IAI WESTWIND

SERVICE BULLETIN

INDEX

FIGURE 1A

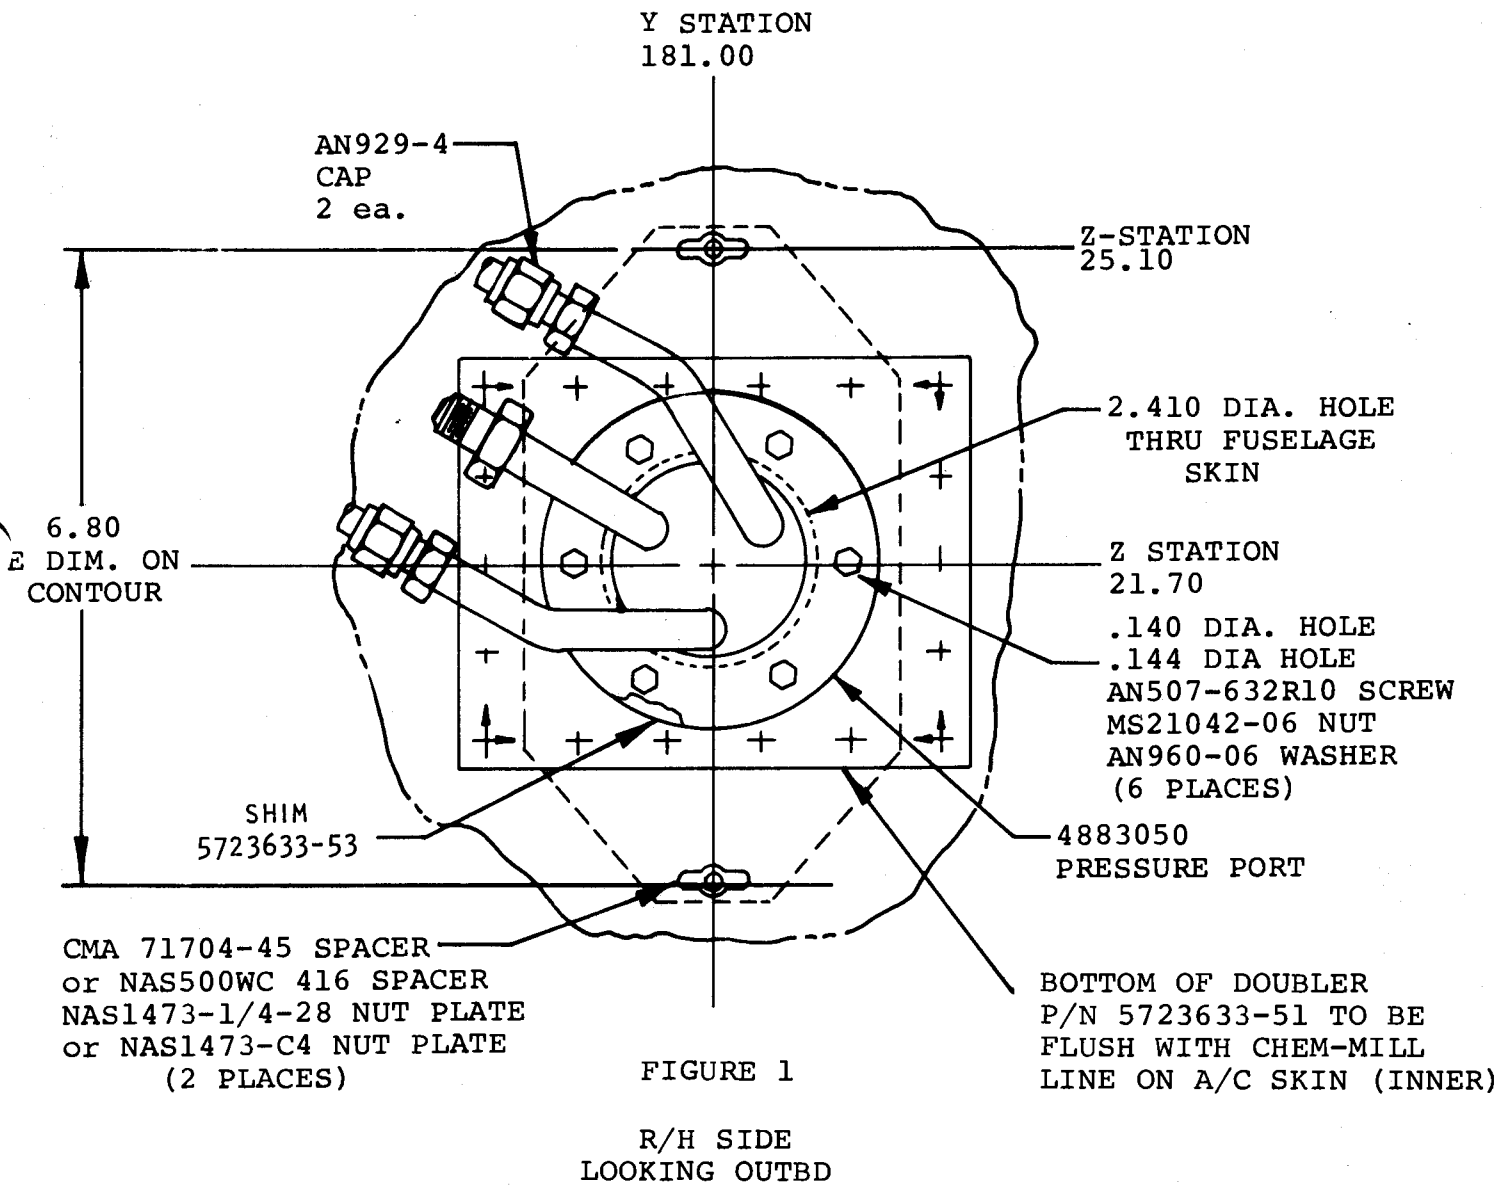
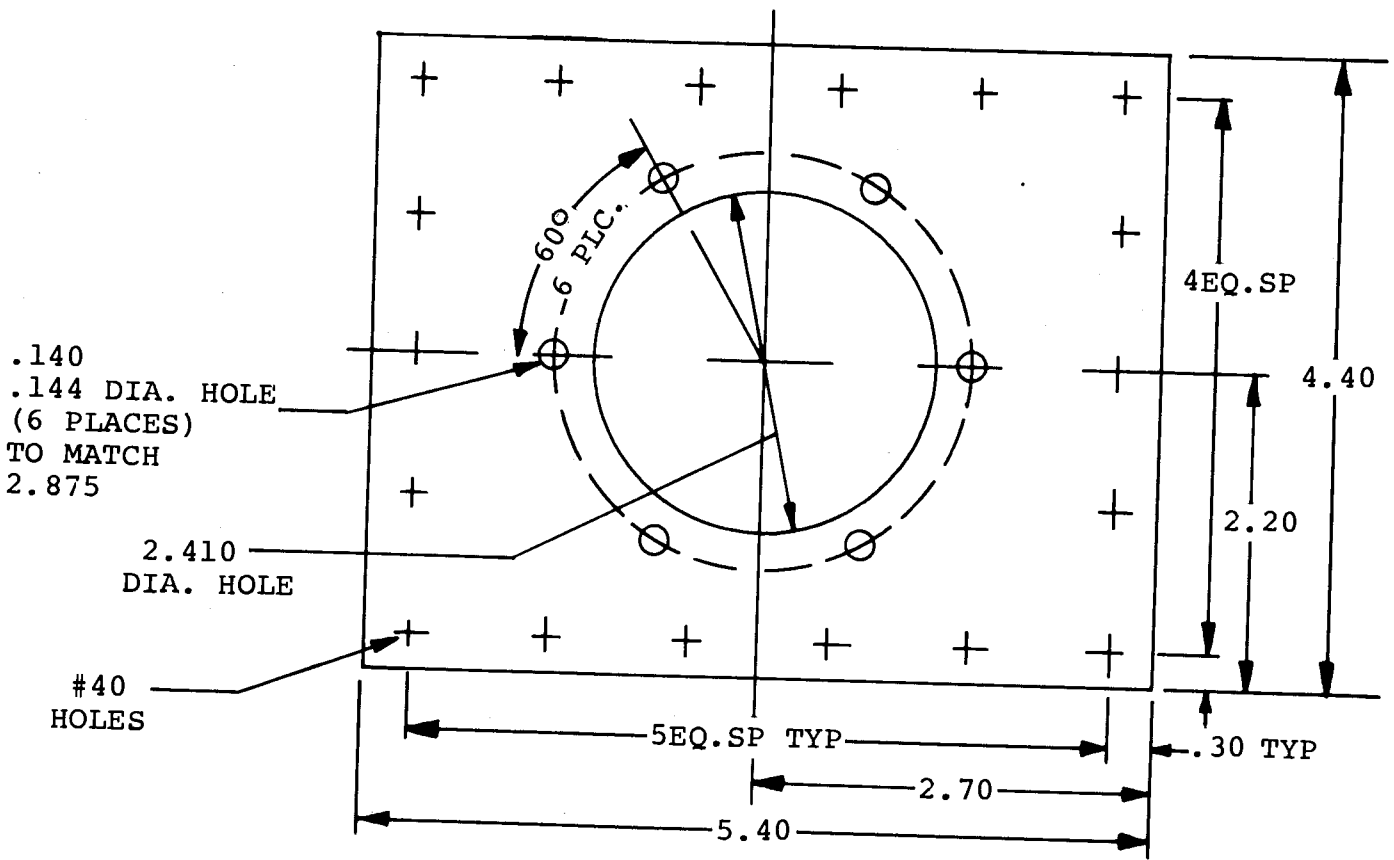
- (1) Remove soundproofing material below R/H emergency hatch, between frames Y-174 and Y-184.
- (2) Locate Y-Station 181 and mark, locate Z-Station 21.70 (water line) and mark. (Refer to Figure 1.)
- (3) Fabricate a doubler (P/N 5723633-51) from 2024-T3 clad .050 thick aluminum as per dimensions in Figure 1A. Etch doubler and treat with Alodine 1201, finish with epoxy primer.

- (4) Measure, mark and cut out hole in fuselage at Y-Station 181 and Z-Station 21.70 (R/H side). Use doubler fabricated above (item 3) as a template for rivet holes and static-port retaining screw holes location (Figure 1).
- (5) Drill .250 inch holes for static-port cover as per dimensions in Figure 1. Attach (2 each) nut-plates P/N NAS1473-1/4-28 and spacers P/N CMA71704-45 to inside fuselage skin.
- (6) Countersink rivet and screw holes for port and doubler from the outside of fuselage skin. Countersink .250 holes for static port cover (Figure 1).

FIGURE 1B

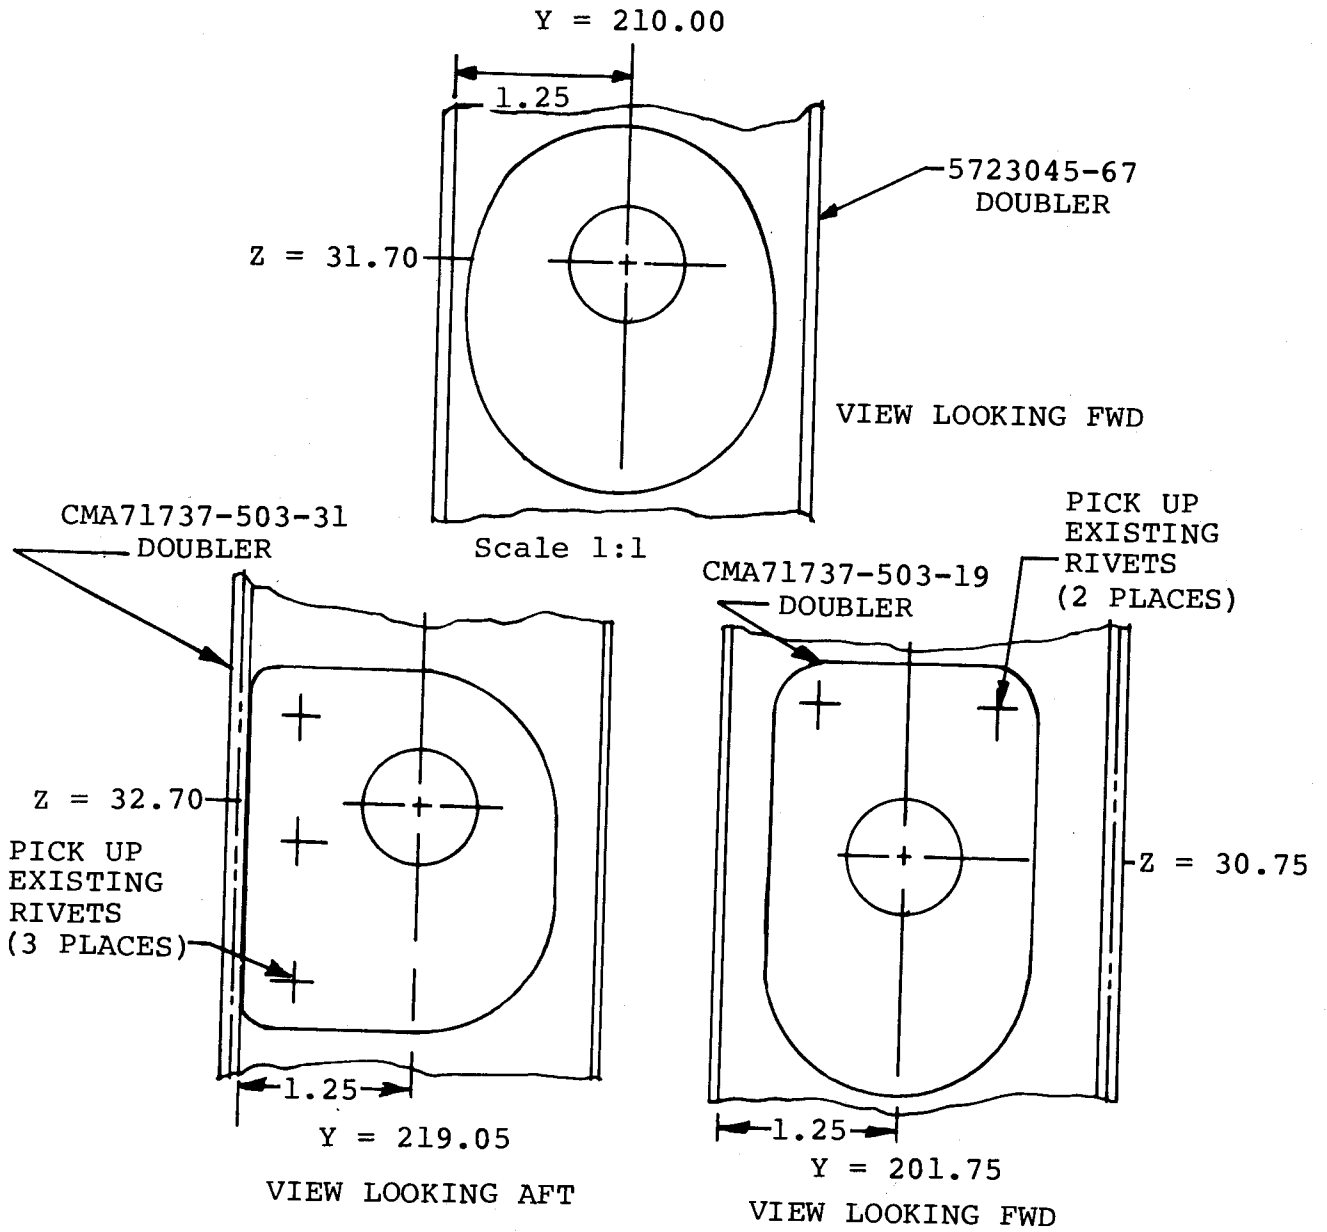
- (b) Doubler for frame 194 must be of sufficient length to cover the existing hole at Z-Station 28.20. (See Figure 1C.)
- (c) Install NAS1033-A3 nut-plate on aft side of frames 210.00 and 201.75 (Fig. 1B). (Same as L/H side.)

POWER SUPPLY INSTALLATION
FIGURE 1

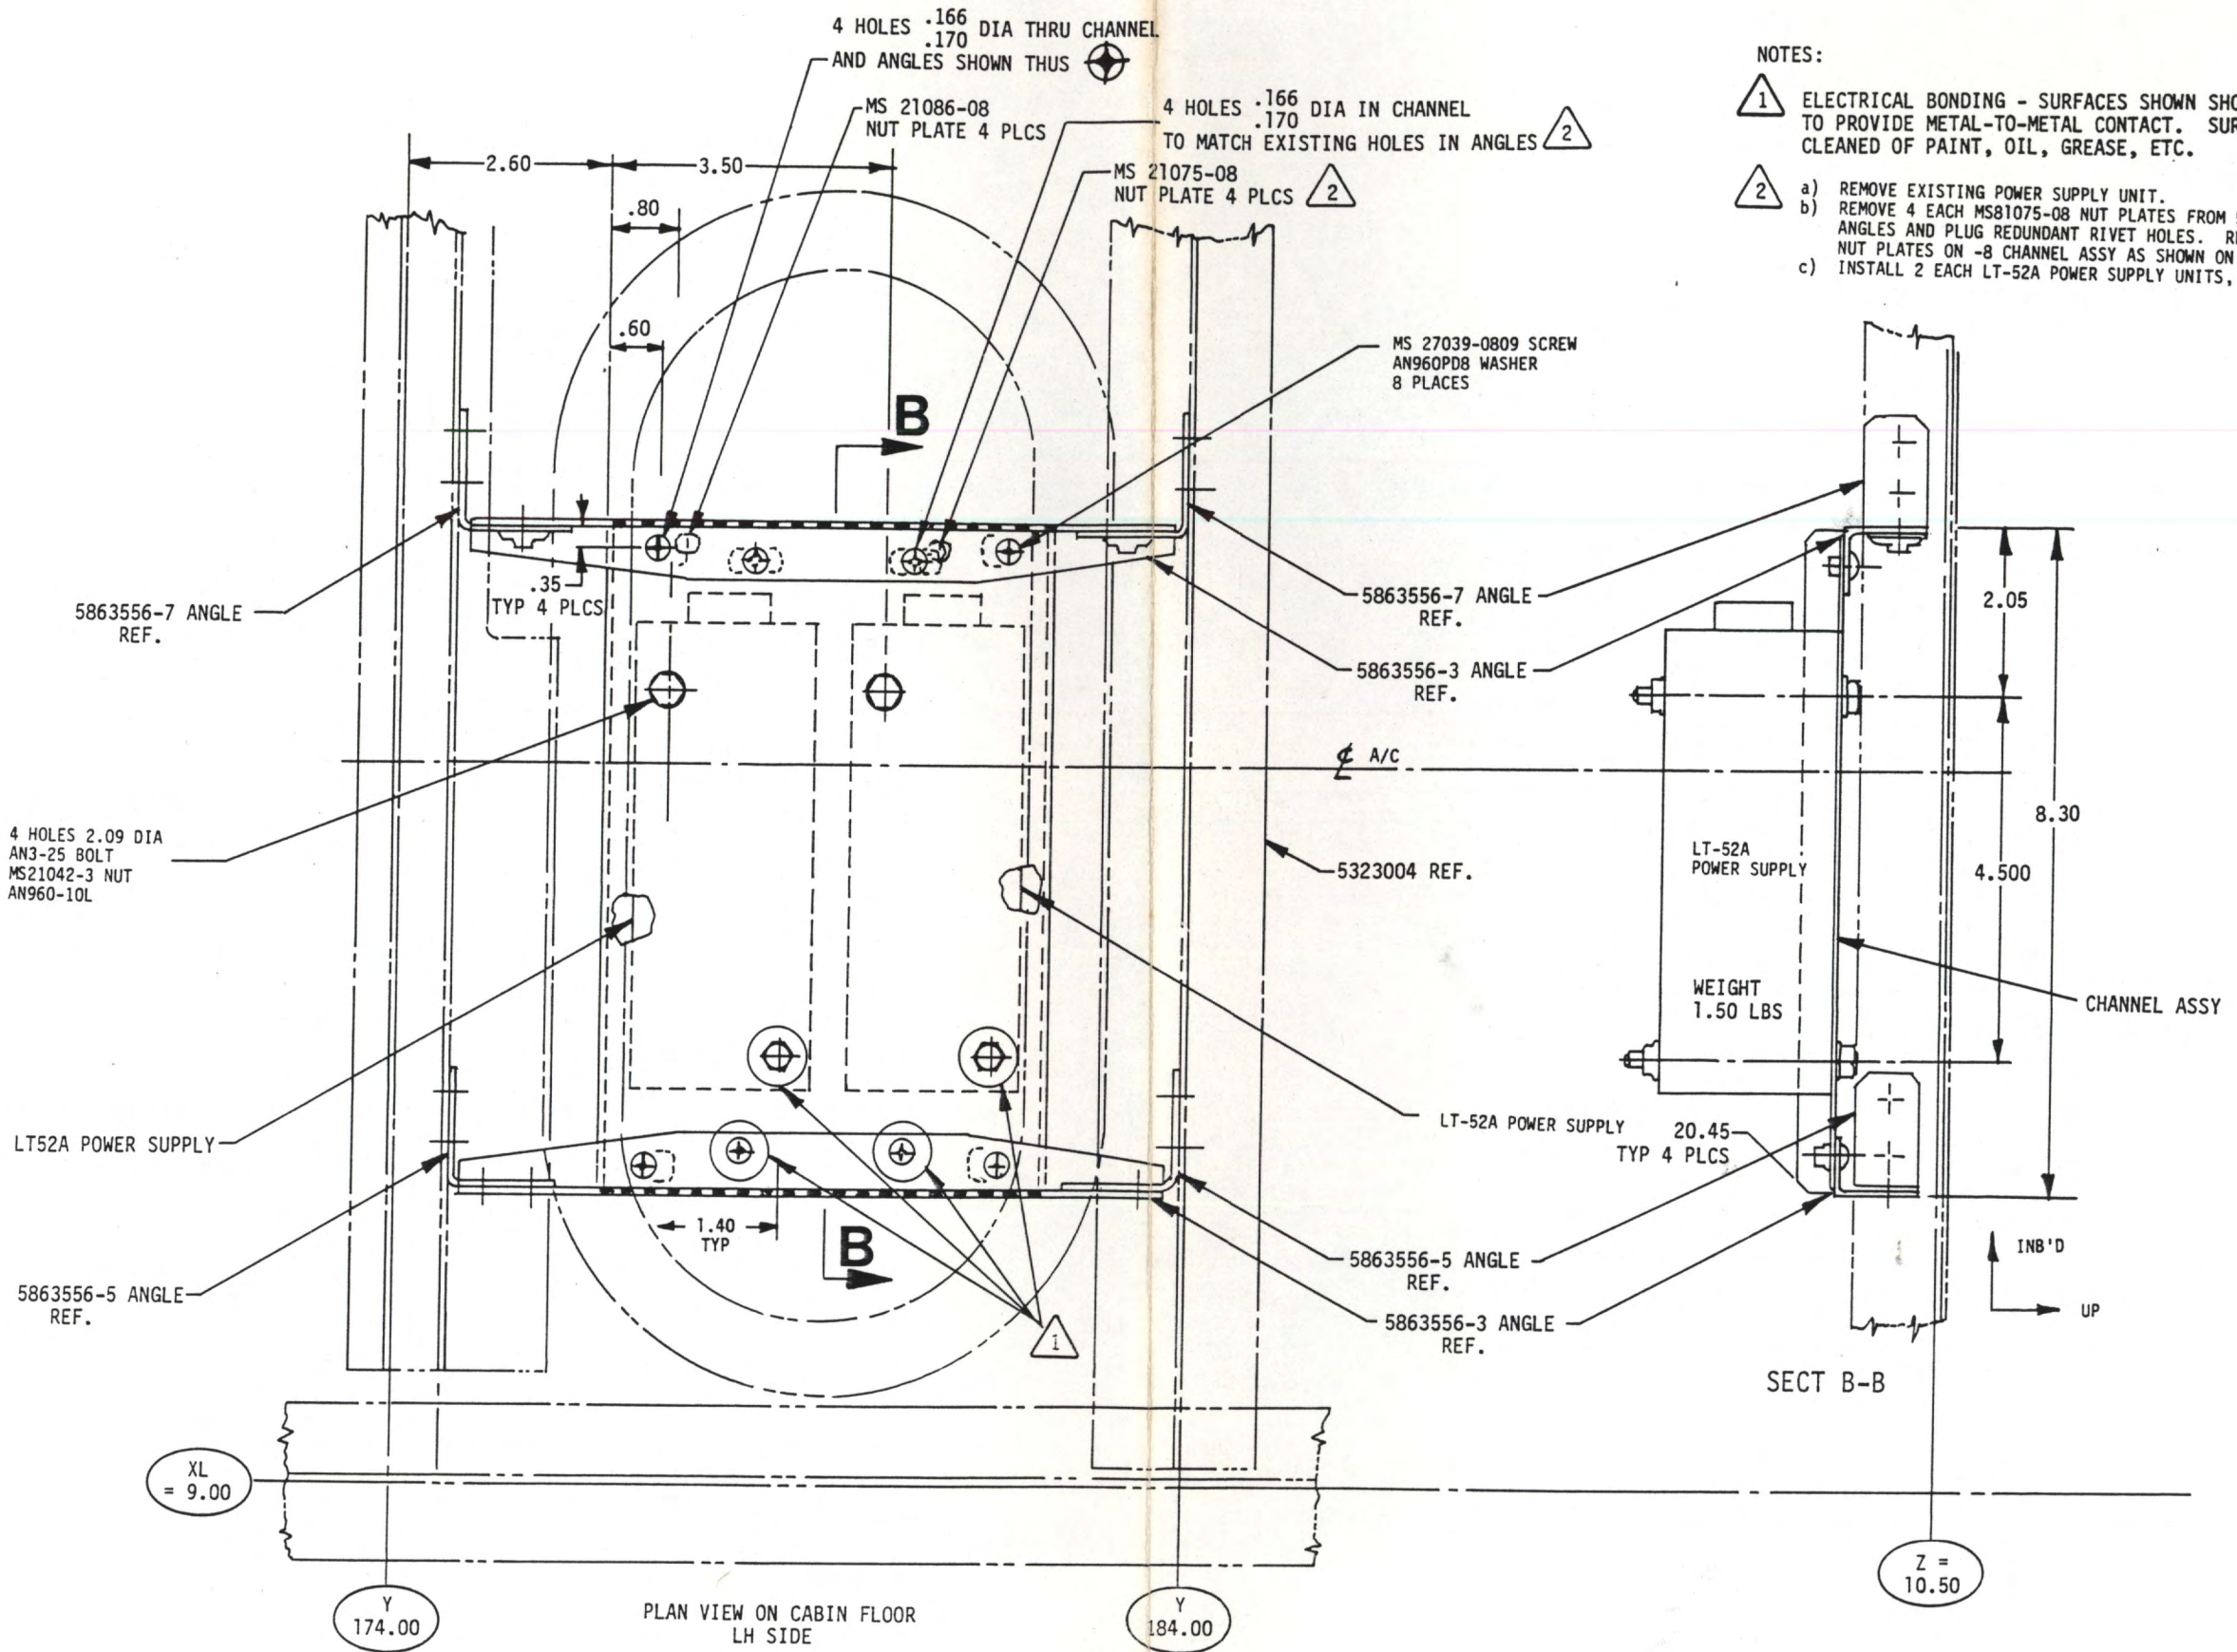
- (3) Modify existing mounting plate angles as shown in Figure #1 to accommodate installation of 2 each KGS LT-52A power supplies and new plate P/N 5863569-3. Install power supplies with AN3-25 bolts.

- (4) Install mount and power supplies to airframe using existing angles and hardware shown on Figure #1 to mount new plate. Label power supplies as B206 and B211 for reference and identification purposes.

FIGURE 1

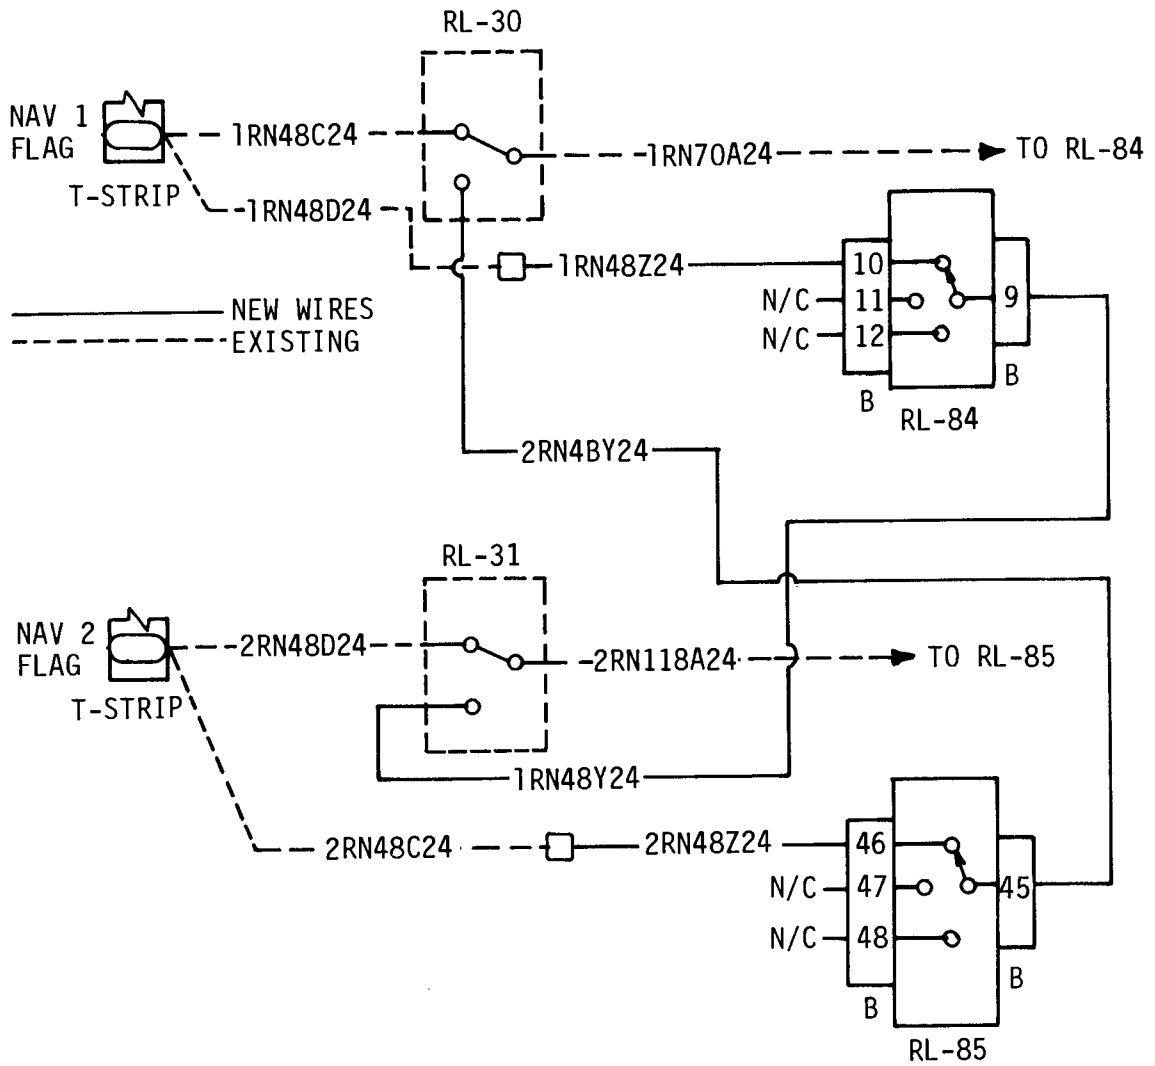
- B. Conformity with the above tests indicates compliance and no further action is required. Unsatisfactory results will require modification in accordance with the remaining steps (reference Figure 1).

FIGURE 2

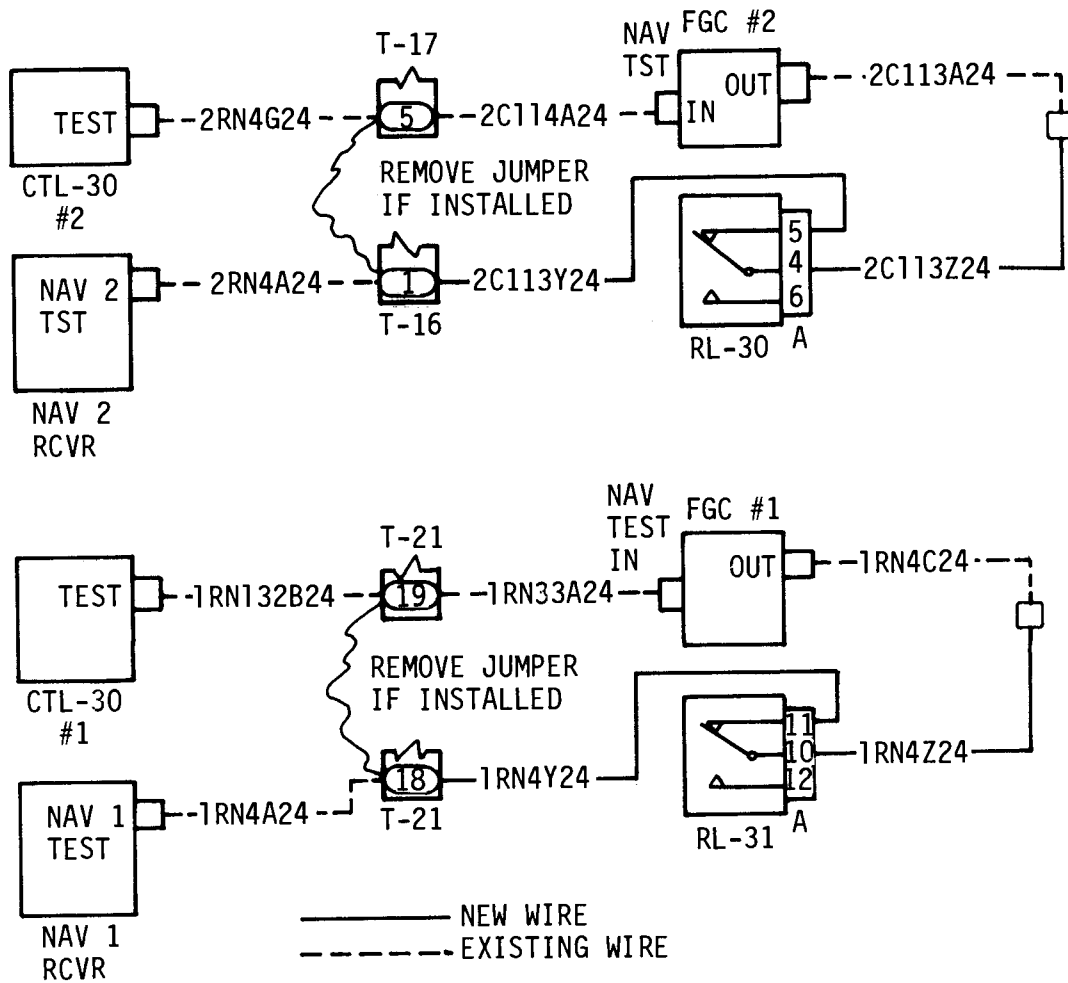
- (2) At copilot position, select "RPT NAV 1" and attempt VIR-30A self-test on #1 NAV CTL-30. Restore Copilot HSI to Normal VOR/LOC.
- B. Self-test in Step A must be inoperative, conformity indicates compliance and no further action is required. Should self-test be operational, modify in accordance with the following steps (reference Figure 2).
